**Camberwell Road, London** for A2Dominion

# Addendum Planning, Design and Access Statement

February 2017

# **BOUNDARY WITH 164 CAMBERWELL ROAD**

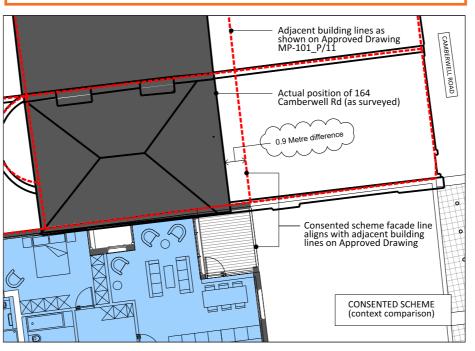
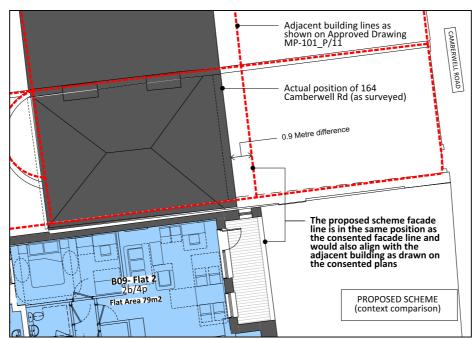
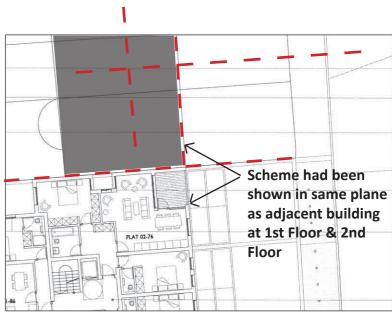
In analysing both the consented scheme and proposed scheme in relation to a 2016 topographical survey commissioned by A2Dominion, it has become apparent that the building line at 1st floor level does not align with the adjacent building (164 Camberwell Road) due to inaccurate context information on the approved planning drawing.

The diagrams to the right compare the adjacent "building lines" as drawn at planning stage (dashed in red) with the 2016 topographical and both the consented and proposed scheme, and indicate that the proposed scheme (based on the frame as-built) is in the same position as the consented scheme, but that the adjacent building lines are approximately 0.9 metres further back from the street than originally assumed at design stage.

The proposed facade line is in the same position as the consented facade line.

The position of the adjacent building shown on the consented plans varies from the actual position of the building as surveyed.

# PLAN - Basement Floor

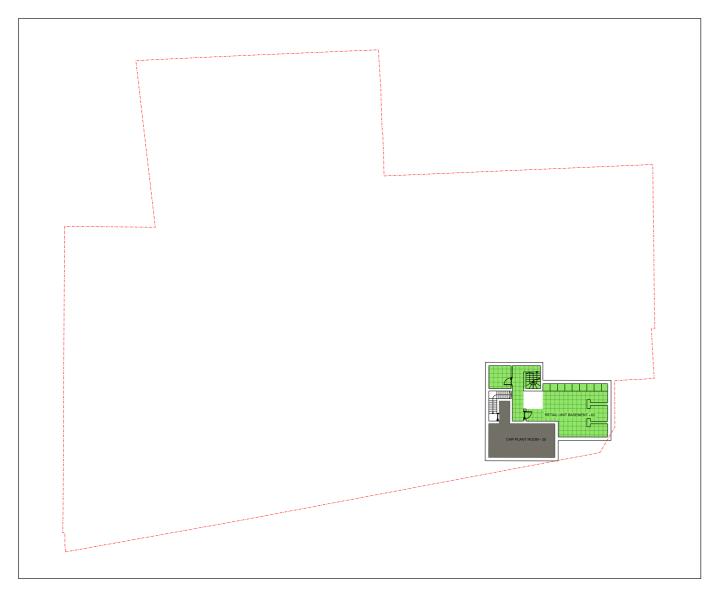
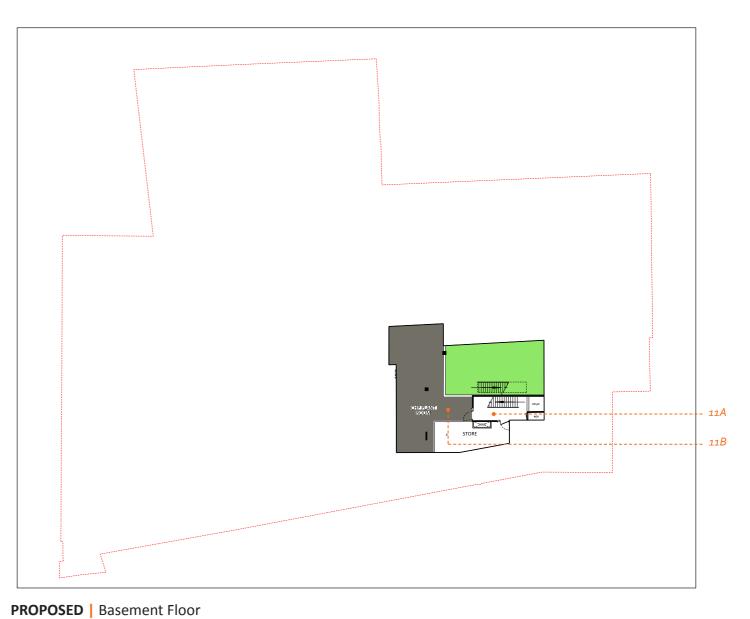
Block 11:

11A Internal circulation moved and re-orientated.

11B Plant room size increased.
